Cycleways and Bicycle Facilities Advisory Committee

Minutes

TUESDAY 21 NOVEMBER 2017

4.5. Darley Road / Clovelly Road - pedestrian / bicycle refuge
(D02301870-DP)

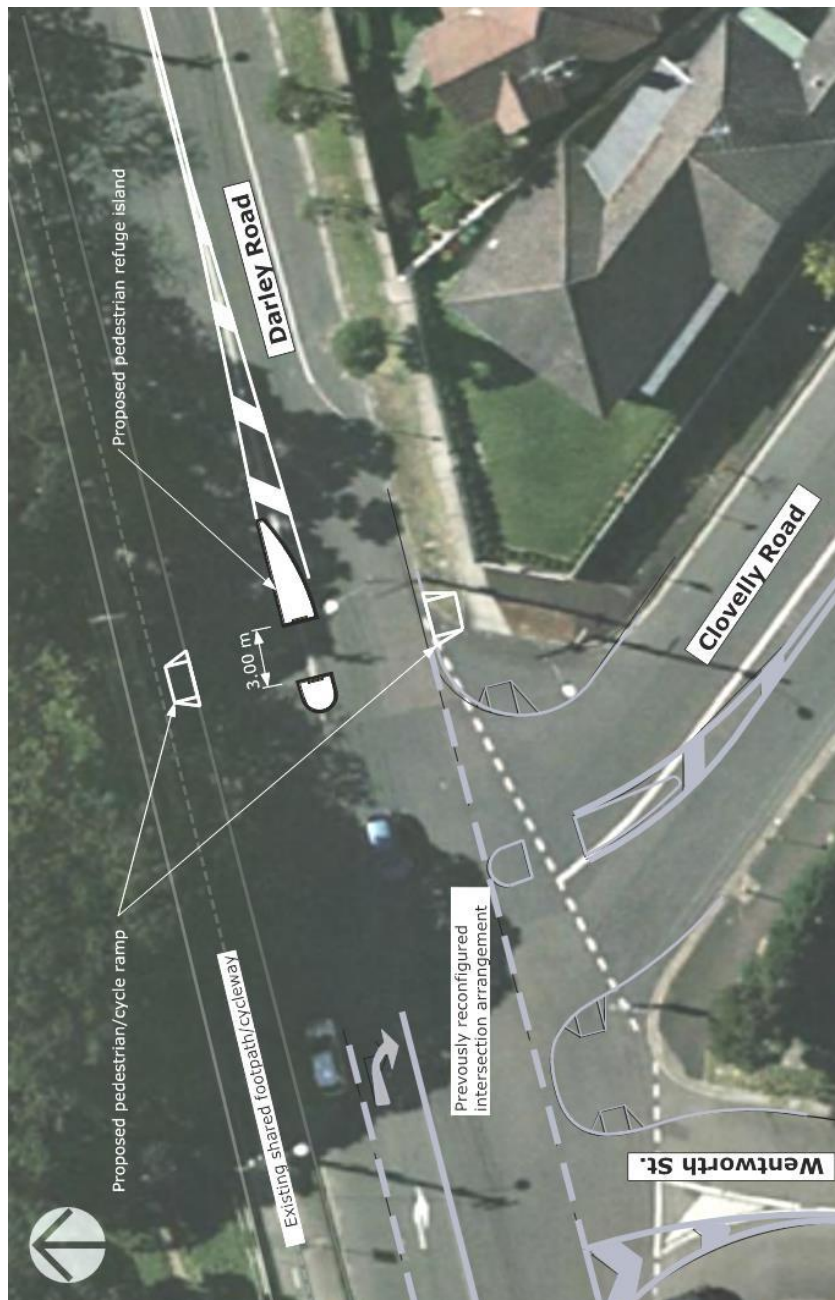
1. A pedestrian refuge island be installed in Darley Road, Randwick, at the intersection with Clovelly Road;
2. Detailed construction plans be brought back for the consideration of the Committee, prior to construction; and
3. This project be included on the list of unfunded works.

This project is scheduled for detailed design in the first half of 2018, with construction likely to occur within the 2018 / 2019 year.

That the information be noted.

4.6. Oxford St pedestrian and cycle paths

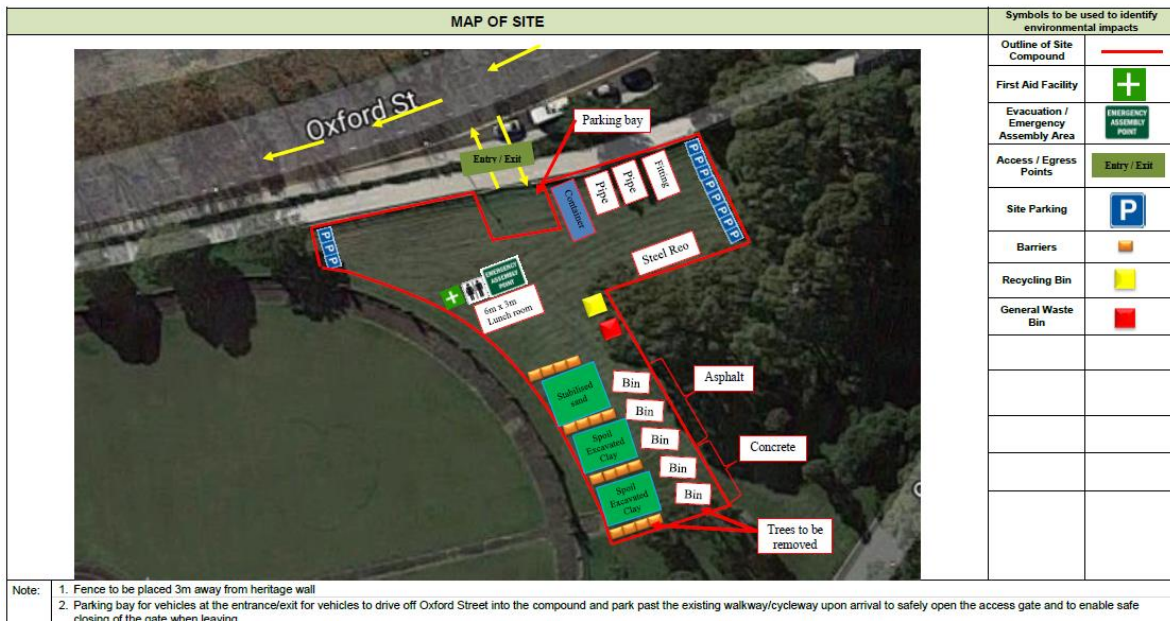
Ms Poon requested that lighting be a priority to provide visibility and improve safety along the footpath and cycleway at all hours of the day.

1. Sydney Water be advised to ensure all facilities are installed to the relevant Austroads standards for footpaths and bike paths – especially the road plates and the required warning signage.
2. Sydney Water submit and undertake an appropriate inspection and rectification regime for this component of their facility, and, that it be to the satisfaction of Randwick City Council.
3. Adequate lighting be provided to alert pedestrians and cyclists of the construction work, ramps and gate opening at night.
